# STUDER

## Service Information

Switching Code 1.080.811.00

Service Information SI 44/79 E

TABLE 6 SWITCHING CODE 1.080.811

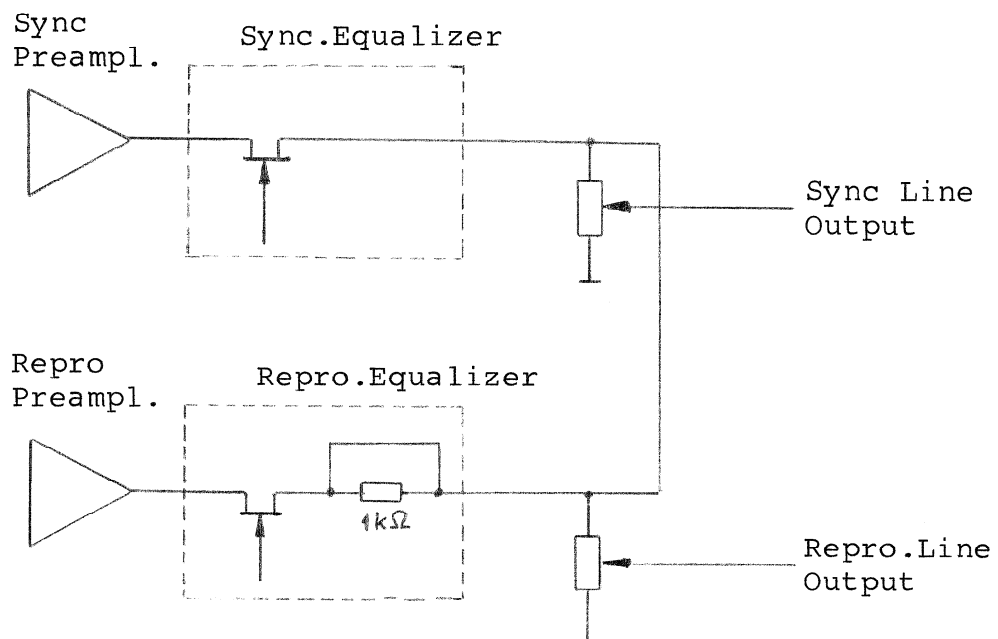
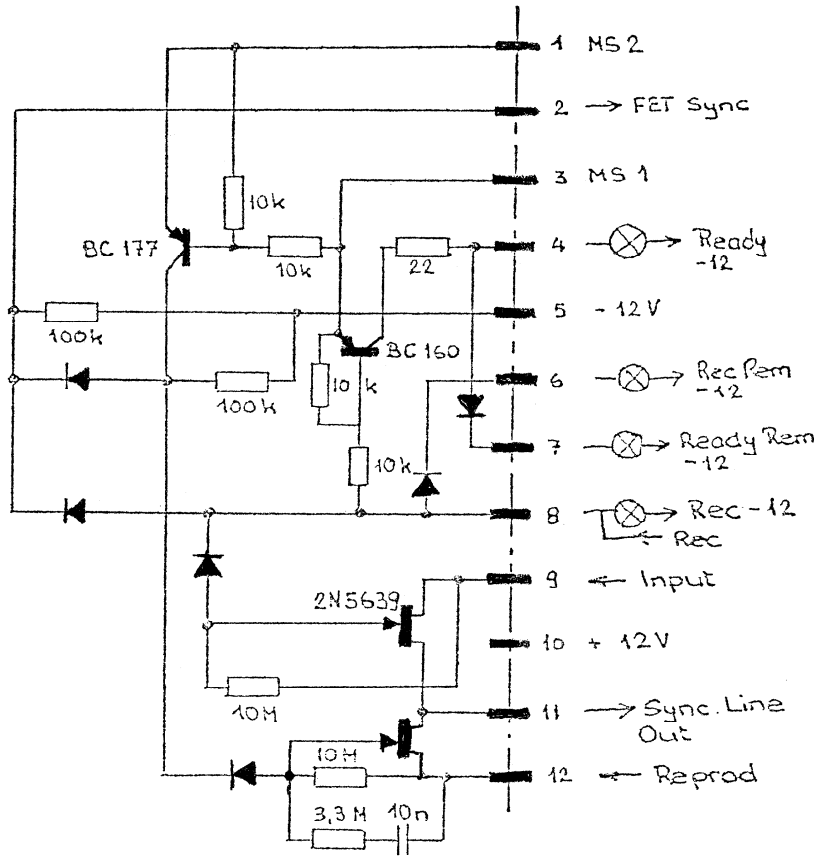
Using the switching code print No. 1.080.811 on the equalizer print 1.080.814/815/865/875 one resistor of 1 kOhm has to be shortened.

REASON: In SAFE Position - a level jump of 1 dB occurs between REPRO - OUTPUT and SYNC - OUTPUT (see truth table : SWITCH - POSITION : SAFE)

Resistor to be shortened:

1.080.814	:	R21	1 kOhm
1.080.815	:	R5	1 kOhm
1.080.865	:	R8	1 kOhm
1.080.875	:	R5	1 kOhm
